Final Regulatory Impact Analysis and
Summary and Analysis of Comments

Control of Vehicular Evaporative Emissions

February 1993

U.S. Environmental Protection Agency
Office of Air and Radiation
Office of Mobile Sources
Regulation Development and Support Division
Engine and Vehicle Regulations Branch

Figure 2-1

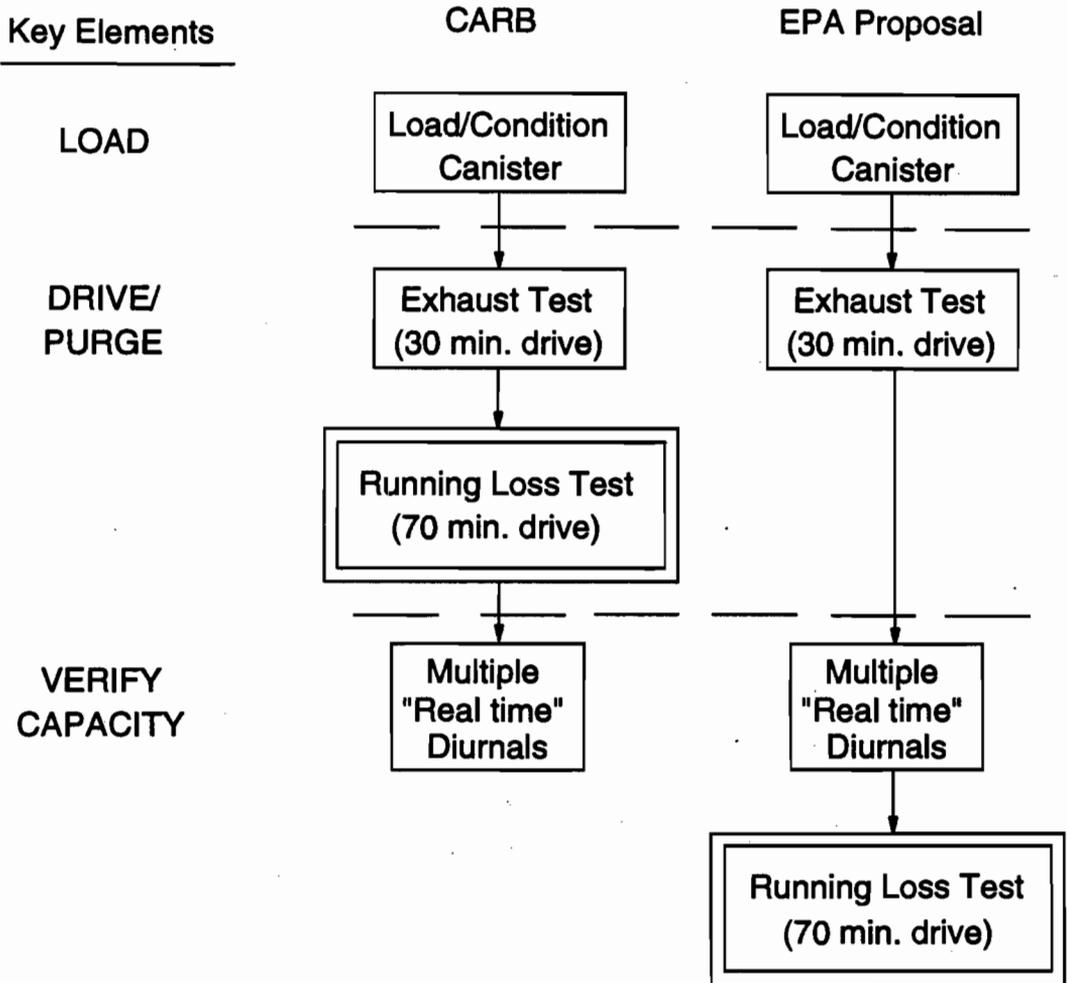
EPA's proposed test sequence was different than that finalized by CARB. CARB's adopted procedure included a 70-minute running loss test between the exhaust and diurnal emission tests, allowing a total of approximately 100 minutes of driving for vehicles to purge their canisters.

To address these concerns, CARB suggested in the same letter adding one of two alternative methods to verify purge during the exhaust emission test. In the first method, purge airflow would be measured and compared with a similar measurement during the running loss test to verify a consistent purge rate. In addition, the change in canister mass during the exhaust emission test would be measured to ensure that approximately 70 percent of the canister's working capacity before breakthrough had been made available. In the second method, CARB would conduct a special test with two diurnal heat builds directly following the exhaust emission test. CARB proposed that these additional test requirements would apply to certification and, potentially, in-use testing. In addition, CARB identified the possibility of adopting EPA's proposed test sequence if its other proposed changes were found not to be viable.

Manufacturers opposed CARB's suggestion of weighing canisters during a test run. They commented that such an operation could jeopardize the repeatability, reliability, and validity of test results because of the need to remove and handle components of a vehicle's emission control system.

Ford and Chrysler came forward with nearly identical approaches for a potential compromise, consistent with CARB's proposed option for a special two-diurnal test to ensure sufficient purge in short-trip driving patterns.^{8,9} Ford and Chrysler recommended that EPA finalize CARB's adopted procedure, with minor modifications, for certification testing. For recall testing, they suggested an abbreviated test, consisting of the preconditioning and exhaust emission test, followed by a moderate-temperature hot soak test, and two diurnal heat builds. Since Ford and Chrysler offered no explanation of the differences for recall and certification testing, EPA understands that they were merely responding to EPA's desire to adopt an enforceable in-use test that would ensure adequate purge rates. The standard for recall testing would be 2.5 grams for vehicles with fuel tank capacity less than 30 gallons (110 liters), and would allow for exclusion of nonfuel emissions. Vehicles with larger fuel tanks would be subject to a 3-gram standard. No explanation of the basis for these relaxed standards was stated.

GM opposed the use of any alternate emission measurement to verify purge.¹⁰ GM claimed that the alternate procedures under consideration would overburden the industry and increase the severity of the full evaporative test procedure. GM claimed, though without explanation, that an alternate emission measurement, with the existing 2-gram standard, would increase the overall purge requirement by 25 percent—with no air quality benefit.

The various suggested improvements to CARB's adopted test sequence are also not satisfactory. Measuring a change in canister mass during the exhaust emission test is an inappropriate way to verify purge during short trips. Any requirement for a change in canister mass would effectively be a design standard, because it would dictate requirements for certain vehicle components rather than demonstrating the vehicle's performance to an emission standard. EPA strongly prefers performance standards over design standards because design standards can unnecessarily constrain manufacturers' design options, and may not be effective in improving in-use performance in that they may not address possible unforeseen mechanisms by which emissions occur. Also, the removal of a canister to determine its mass change would involve an unnecessary intrusion into the control system, both before and after the exhaust emission test.

Measurement of purge airflow is also an inappropriate way to verify purge. Requiring some specified distribution of purge in different driving conditions would effectively be a design standard, and therefore not a preferred alternative for the reasons just noted. Also, there is an enormous degree of latitude in defining the criterion for acceptable purge distribution, so that setting such a criterion would require a subjective evaluation of what constitutes an optimum strategy, to the exclusion of other reasonable strategies. The nature of design standards virtually ensures that any such criterion would either be ineffective in ensuring in-use emission control, or would unnecessarily restrict manufacturers' flexibility in vehicle design, or both. EPA believes the goals of establishing an effective, yet nonrestrictive purge flow criterion are irreconcilable, as evidenced by the fact that CARB has been unable to reach an agreement with manufacturers. Measurement of purge airflow may also require temporary, intrusive vehicle modifications that could impact vehicle evaporative emissions and call into question the test results.

A special test measuring vehicle emissions from two diurnal heat builds immediately after the exhaust emission test is the only suggested modification to CARB's test procedure that addresses EPA's need for assurance of adequate purge. This assurance comes from the fact that such a test measures emissions following a relatively short amount of driving, as is common in use. Measuring emissions is necessary to establish a performance standard, and to prevent the need for any intrusive measurement of secondary variables such as canister mass or purge airflow. A supplemental procedure could verify sufficient purge for short trips without being more stringent overall than the full three-diurnal test. Such a procedure would only change the overall test requirements for vehicles that are indeed insufficiently purging early in the test.
